# ADDENDUM NO. 2

**RFQ &P for Districtwide Underground Utility Mapping & Condition  
Assessment Services**

**SOCCCD - BID No. 356D**

South Orange County Community College District

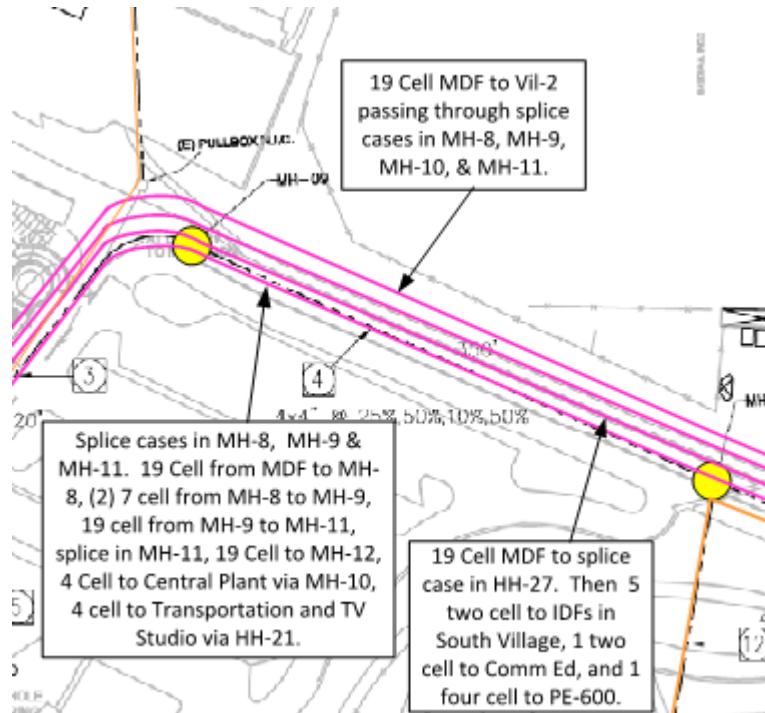
Q11: With regards to the telecommunications and power vault inventory requested, can the District provide its preferred template for this report, or will the below example meet the District's needs?

A11: SOCCCD has no current template for these scope of services. The final format for each College will be determined with the successful proposer. As it relates to the sample provided above, the notes regarding the splice cases are confusing, as they do not specify the number, size of splice cases, or the routing. Additionally, the condition assessment will need to be addressed, whether it be compiled or separate. Lastly, each building should be identified by its descriptive codes assigned by each College.
